HYUNDAI NEW THINKING. NEW POSSIBILITIES. Technical Service Bulletin	GROUP TRANSFER CASE	NUMBER 15-TC-001
	DATE AUGUST 2015	MODEL(S) TUCSON (LM)
SUBJECT: 4WD COUPLER ASSEMBLY ACTUATOR MOTOR REPLACEMENT DTC P1820, P1821, P1822, P1823 & P1824

Description: This bulletin contains information on the Tucson (LM) 4WD Coupling Assembly components that can be replaced separately as service parts. Do not replace the 4WD Coupler Assembly for the DTC's listed below. Follow this repair procedure and replace the Coupling Actuator Motor and Harness 4WD Coupling only.

Parts Information:

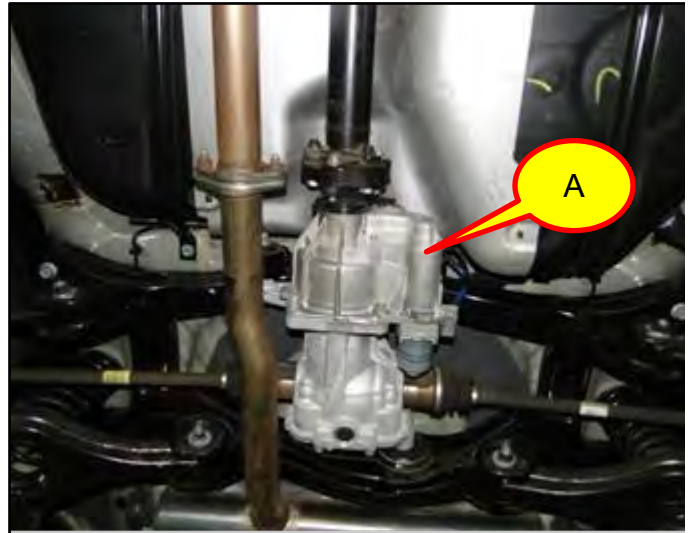
Part Name	Before	After	Qty.
Actuator Motor	478103B500	478103B520	1
Harness 4WD Coupling (Vehicles built before February 7, 2013)	478913B110	478913B310	1

Before February 7, 2013
2 pin + 1 pin connector

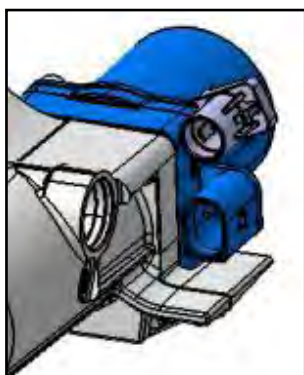
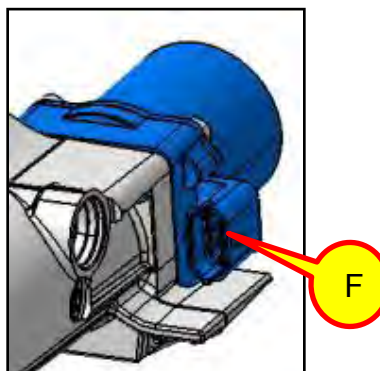
8. Replace the 4WD coupling harness if the vehicle is built before February 7, 2013.

Vehicles built after February 7, 2013 do not require the 4WD connector harness to be replaced.

Vehicle Production Date	Part Description	Old Part Number	New Part Number
Before February 7, 2013	One: 2 pin connector and one: 1 pin connector	478913B110	478913B310
